Access Compliance Report

Public Rights-of-Way

Intersection ID: 43518	Main Street: ANDREW_COLTEN_CT	Cross Street: STONE_BLUFF_CT	Location: S
ADA ID: 8AD61446E257	Ramp Type: PerpDiag	Initial Pass/Fail: Fail	Overall Compliance: No
Severity Score: 8.75			
Codes/Mitigation Info/Possible Solution		Field Measurements/Component Compliance

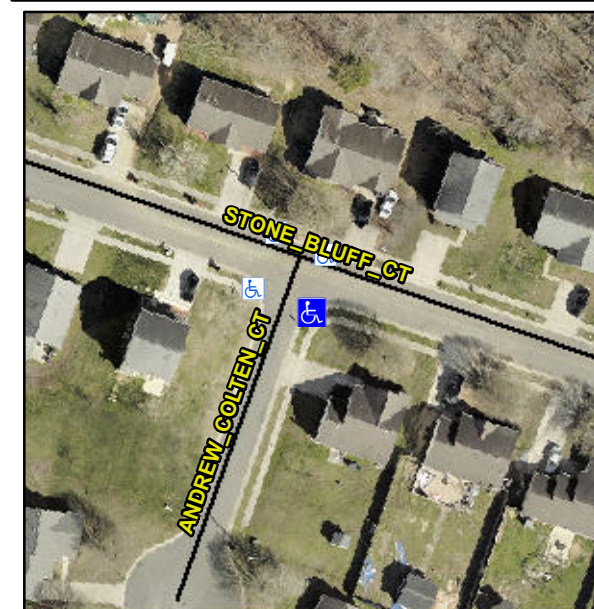
Not Found, R304.5.1

Compliance	Description	Data	Compliance	Description	Data
N/A	Ramp Length (in)	49.0	Yes	Ramp Slope (%)	5.7
No	Ramp Width (in)	45.0	Yes	Ramp XSlope (%)	0.3
N/A	Flare Type LT	N/A	N/A	Flare Type RT	N/A
N/A	Flare Slope LT (%)	N/A	N/A	Flare Slope RT (%)	N/A
N/A	Flare Traversable LT?	N/A	N/A	Flare Traversable RT?	N/A
N/A	Landing Length (in)	N/A	N/A	DWS Provided?	N/A
N/A	Landing Width (in)	N/A	N/A	DWS Contrast?	N/A
N/A	Landing Slope (%)	N/A	N/A	DWS Length (in)	N/A
N/A	Landing X Slope (%)	N/A	N/A	DWS Full Width?	N/A
N/A	Landing Curb? (Y/N)	N/A	N/A	DWS Offset (in)	N/A
N/A	Shared Landing?	N/A			
N/A	Gutter Ponding?	N/A	N/A	Gutter Slope (%)	N/A
N/A	Gutter Lip Ht (in)	N/A	N/A	Gutter X Slope (%)	N/A
N/A	Painted X Walk1?	No	N/A	Painted X Walk2?	No
	X Walk 1 Direction	To NE		X Walk 2 Direction	To NW
N/A	X Walk 1 Width (in)	N/A	N/A	X Walk 2 Width (in)	N/A
	X Walk 1 Slope (%)	4.3		X Walk 2 Slope (%)	4.5
	X Walk 1 X Slope (%)	4.4		X Walk 2 X Slope (%)	2.3

Remove & Replace Curb Ramp With Two New Directional Ramps or Equivalent.
